Access Compliance Report

Public Rights-of-Way

Intersection ID: 48438	Main Street: BARRANDS_LN	Cross Street: LATHERTON_LN	Location: SE
ADA ID: 1B6DB6D42090	Ramp Type: Perp	Initial Pass/Fail: Pass	Overall Compliance: No
Severity Score: 5			
Codes/Mitigation Info/Possible Solution		Field Measurements/Component Compliance

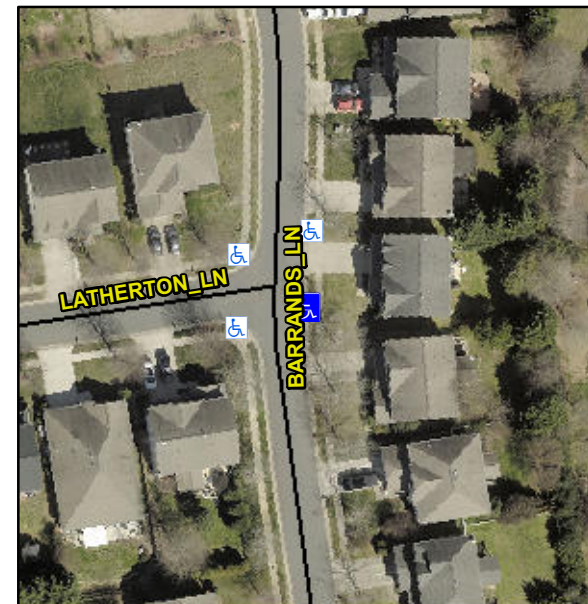
R304.2.1, R304.5.4

Compliance	Description	Data	Compliance	Description	Data
N/A	Ramp Length (in)	47.0	Yes	Ramp Slope (%)	6.0
Yes	Ramp Width (in)	48.0	Yes	Ramp XSlope (%)	1.3
N/A	Flare Type LT	Sloped	N/A	Flare Type RT	N/A
N/A	Flare Slope LT (%)	4.4	N/A	Flare Slope RT (%)	0.3
N/A	Flare Traversable LT?	No	N/A	Flare Traversable RT?	No
No	Landing Length (in)	47.0	Yes	DWS Provided?	Yes
Yes	Landing Width (in)	48.0	Yes	DWS Contrast?	Yes
Yes	Landing Slope (%)	2.0	Yes	DWS Length (in)	24.0
Yes	Landing X Slope (%)	1.4	Yes	DWS Full Width?	Yes
N/A	Landing Curb? (Y/N)	No	Yes	DWS Offset (in)	1.0
N/A	Shared Landing?	No			
Yes	Gutter Ponding?	No	No	Gutter Slope (%)	9.6
Yes	Gutter Lip Ht (in)	0.0	Yes	Gutter X Slope (%)	0.1
N/A	Painted X Walk1?	No	N/A	Painted X Walk2?	N/A
	X Walk 1 Direction	To W		X Walk 2 Direction	N/A
N/A	X Walk 1 Width (in)	N/A	N/A	X Walk 2 Width (in)	N/A
	X Walk 1 Slope (%)	3.7		X Walk 2 Slope (%)	N/A
	X Walk 1 X Slope (%)	0.8		X Walk 2 X Slope (%)	N/A

**Remove & Replace Landing.
Remove & Replace Gutter.**
